ADDENDUM No. 3

Project Name: **CLARENDON COUNTY EMERGENCY MANAGEMENT &
911 COMMUNICATIONS DISPATCH CENTER**

Date: June 06, 2025

A310

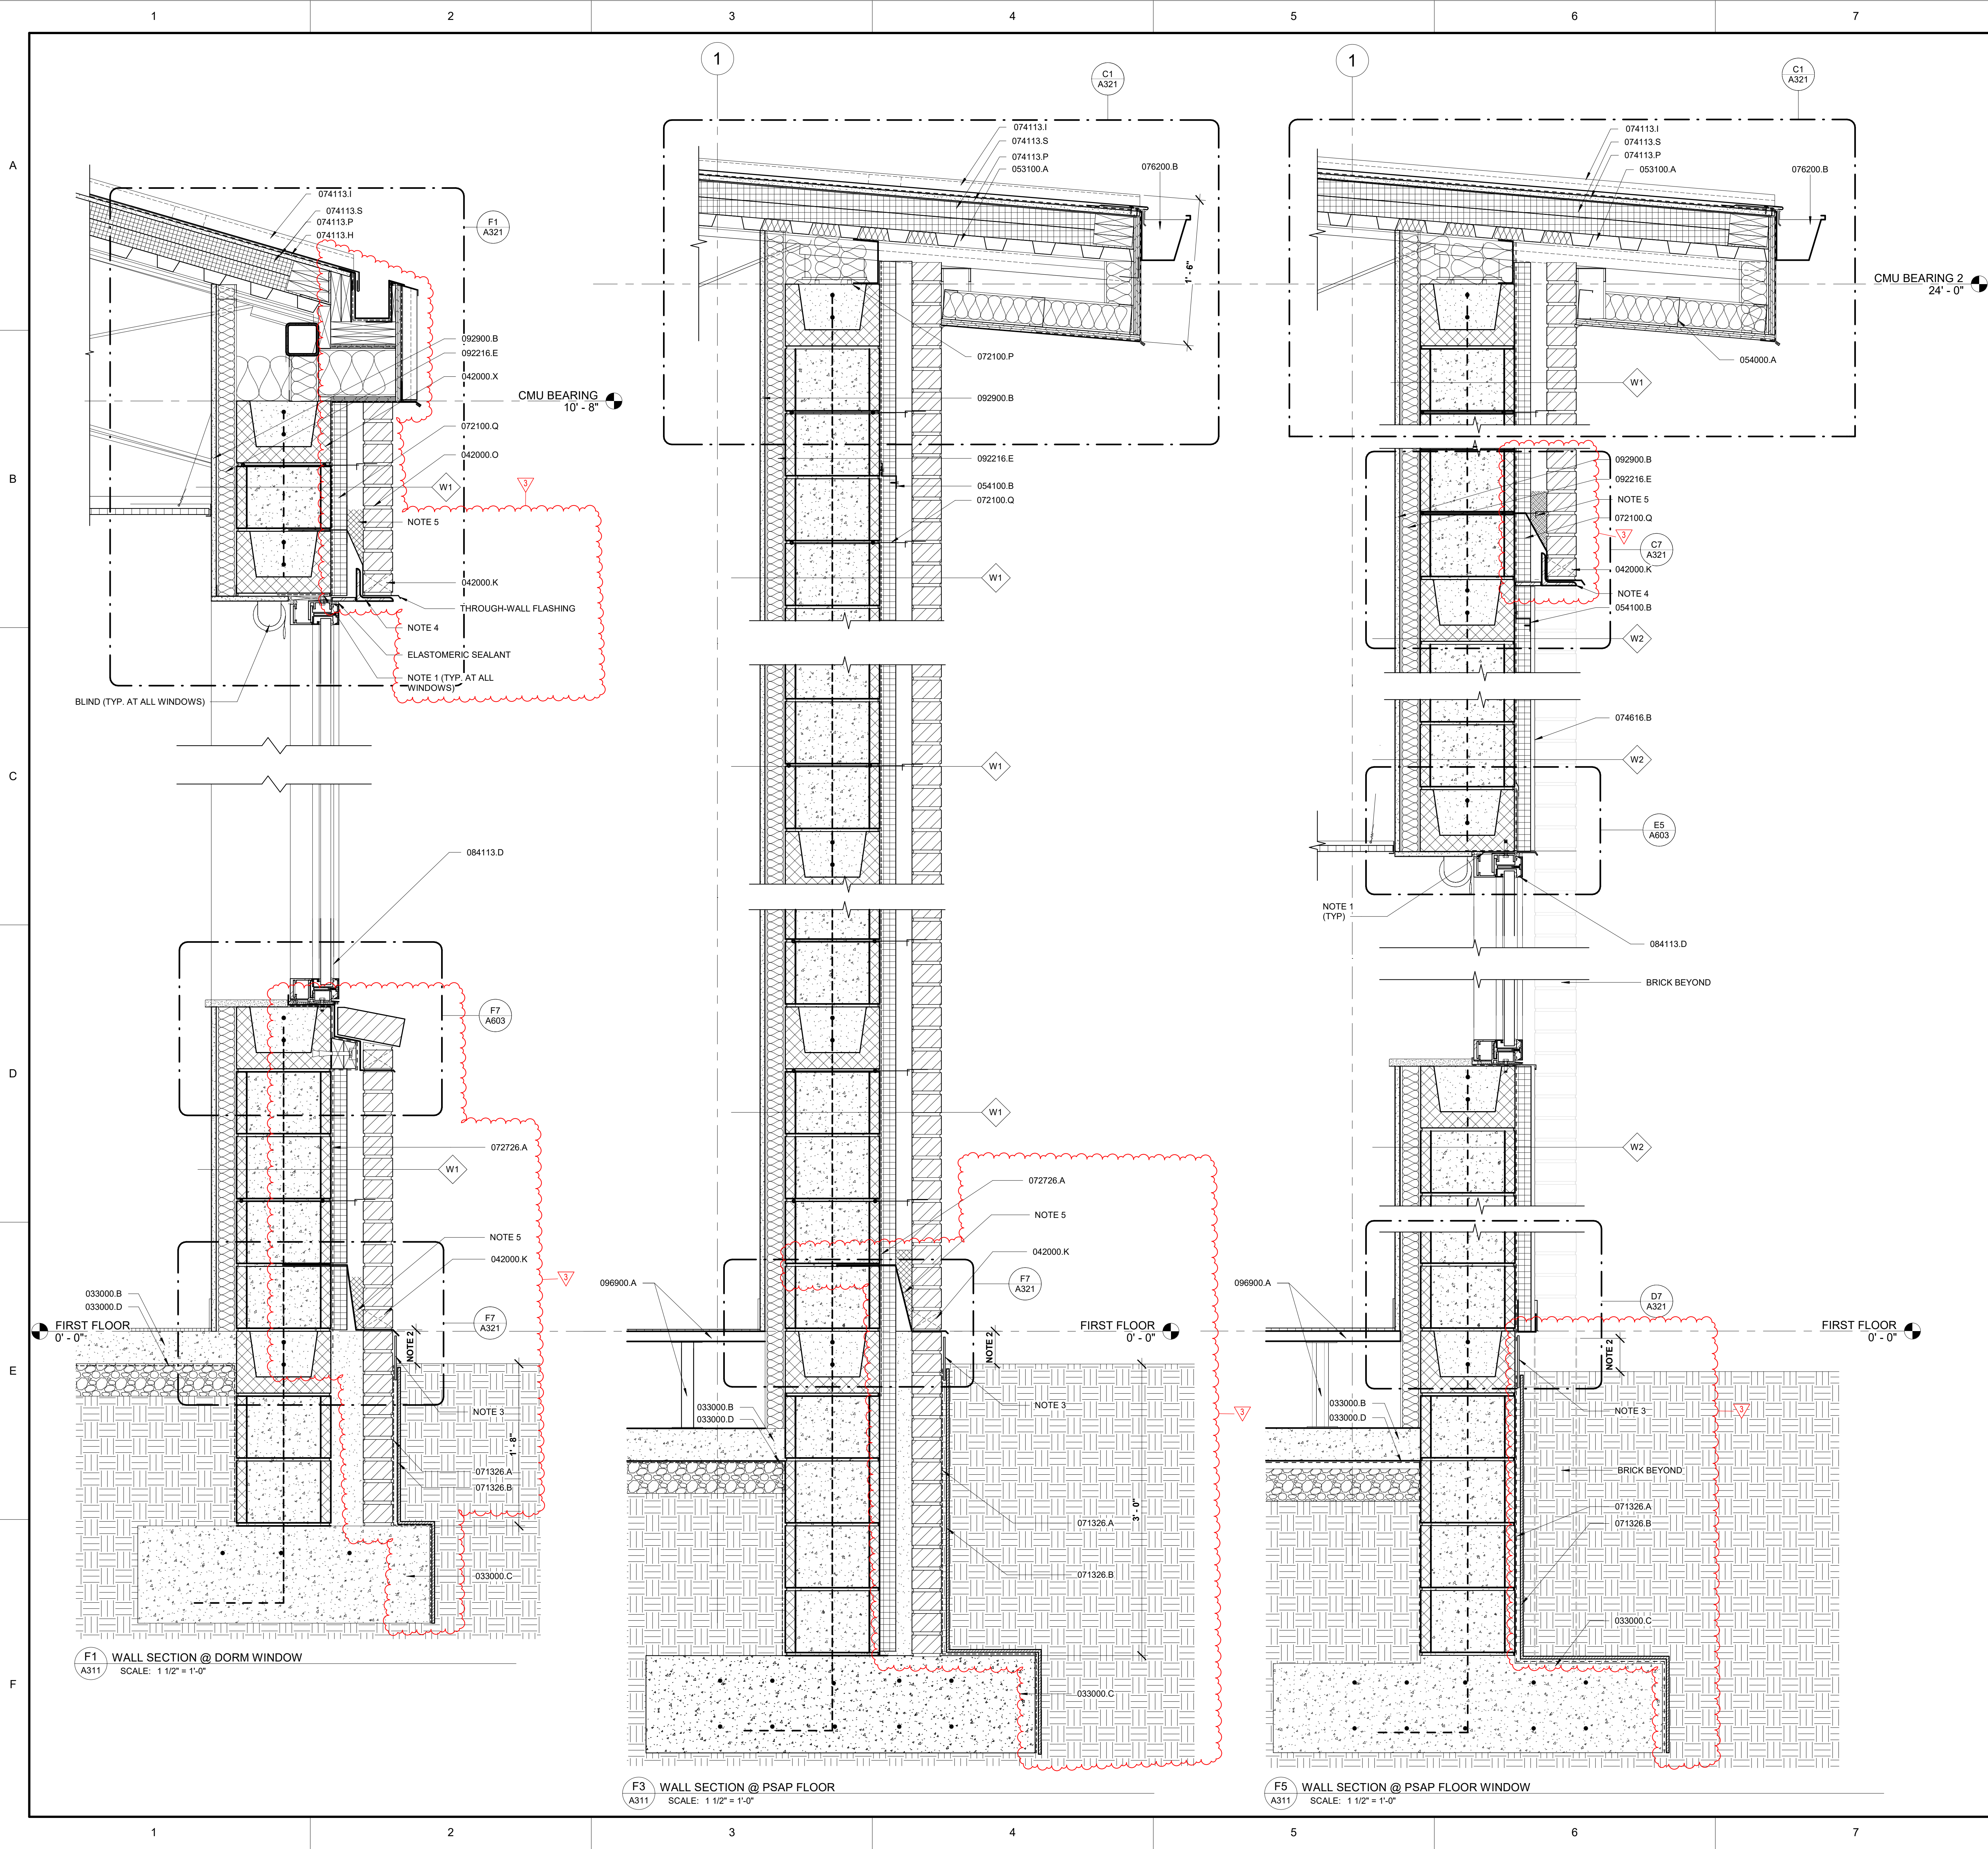
A. See revised Sheet A320 Attachment "F"
5. W5 wall detail on sheet A310 detail F4 shows an extra row of CMU on the footing up to the floor slab elevation for the exterior metal stud framing to attach. Sheet S302 detail 4 shows brick and no CMU masonry under the metal framing. Please advise which is correct.

A. See revised Sheet A320 Attachment "F"
6. If the CMU is installed on the W5 walls as shown on Sheet A320 detail D6, then the self-adhering sheet underlayment (074113.H) will be exposed approximately 2" above the concrete pad shown. How is this going to look as a finished product? Where is this concrete pad shown for this particular application? Please advise.

SHEET NAME	A311
PROJECT NUMBER	
24001	
DRAWN BY	
Author	
CHECKED BY	Approver
DATE	
05.01.2025	
SCALE	1 1/2" = 1'-0"
6/6/2025 11:39:51 AM

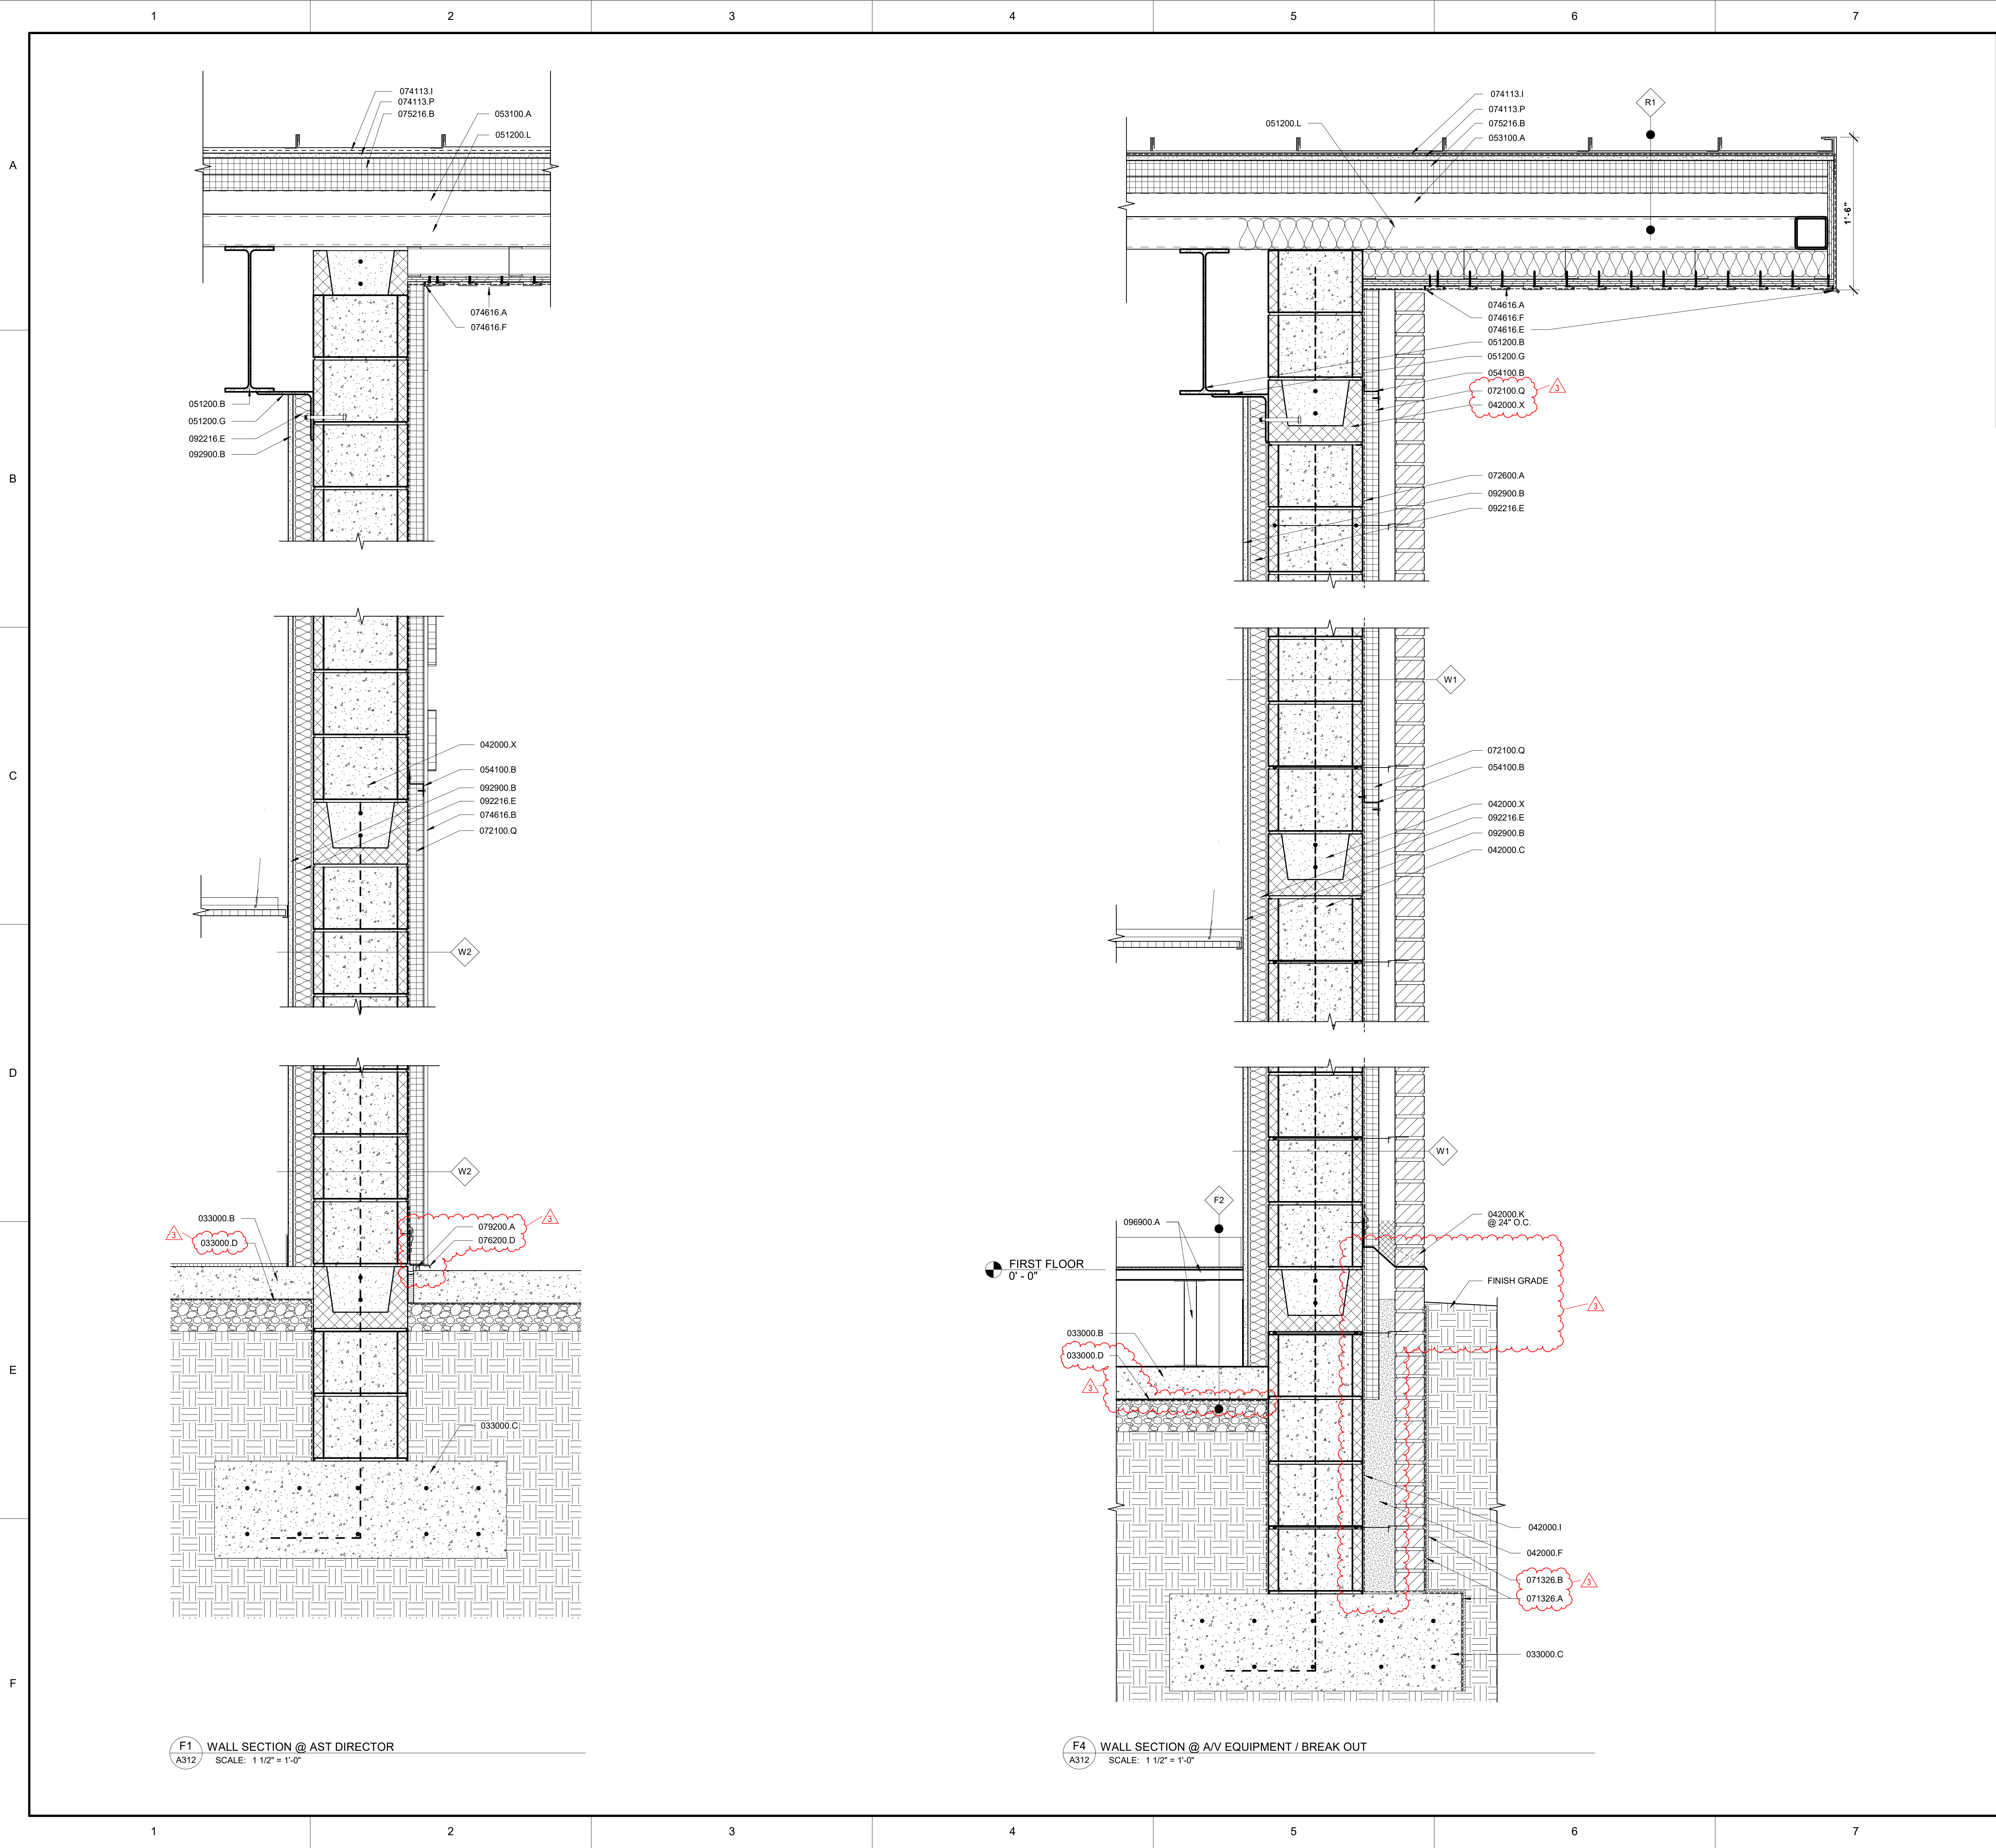
A. Change references in Allowance No. 3 from "Section 312000 Earth Moving" to "see Geotechnical Report".
3. Please provide a header detail for SF5 Storefront Windows?

A. See detail F1 Sheet A311 Attachment "D"
4. Sheet A320 detail D6 shows a drainable weather barrier (074600.O) with a self-adhering sheet underlayment (074113.H) sticking to the drainable weather barrier? Is this possible? It seems like the self-adhering sheet underlayment should stick to the CMU and have a protection board placed against it, in lieu of the drainable weather barrier.

1 WALL CONSTRUCTION TYPE W10
SK-01 SCALE: 1 1/2" = 1'-0"

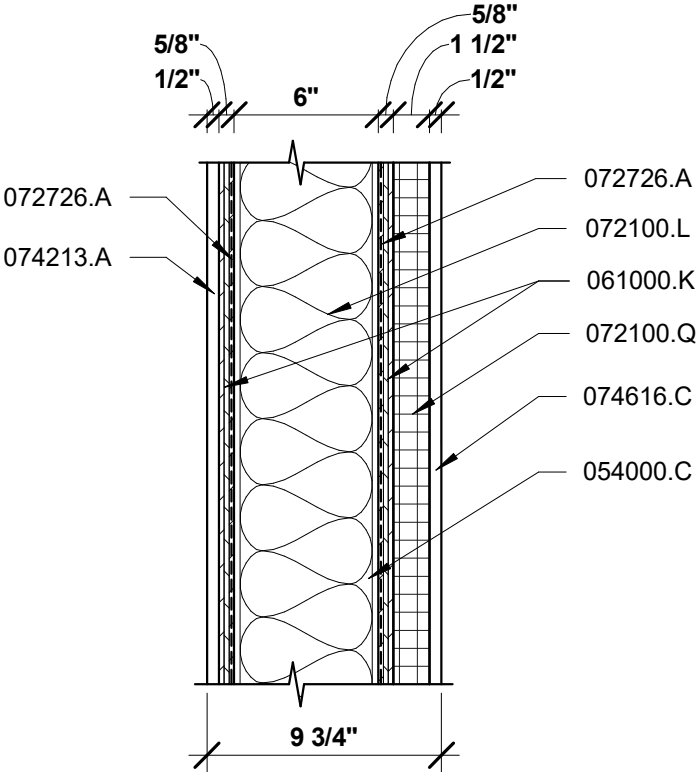
1. Reference Sheet A623:
 - i. Wall type W5: Change "keynote 072726.A (Fluid Applied Membrane Air Barrier)" shown on the outside face of sheathing to "072500.A Building Paper".
 - ii. Roof type R2: Remove reference to "keynote 072726.A" at concrete.
 - iii. Floor type F3: Remove reference to "keynote 093000.E" and replace with, "See Finish Plan".
2. Reference Sheet A313: See sketch SK-02 for additional details for louver sill and roof edge, See Attachment "H"
3. Reference Sheet A602:
 - i. Change reference to "Storefront" on SF8 and SF9 to "Hollow Metal"
 - ii. Drawing Quadrant D1, change "Basis of Design Interior" from "YKK YES 40 FI" to "Hollow Metal". Maintain fire ratings as per original Contract Documents.
4. Reference Sheet A623: Add Wall Type 10, See sketch SK-01, Attachment "G".
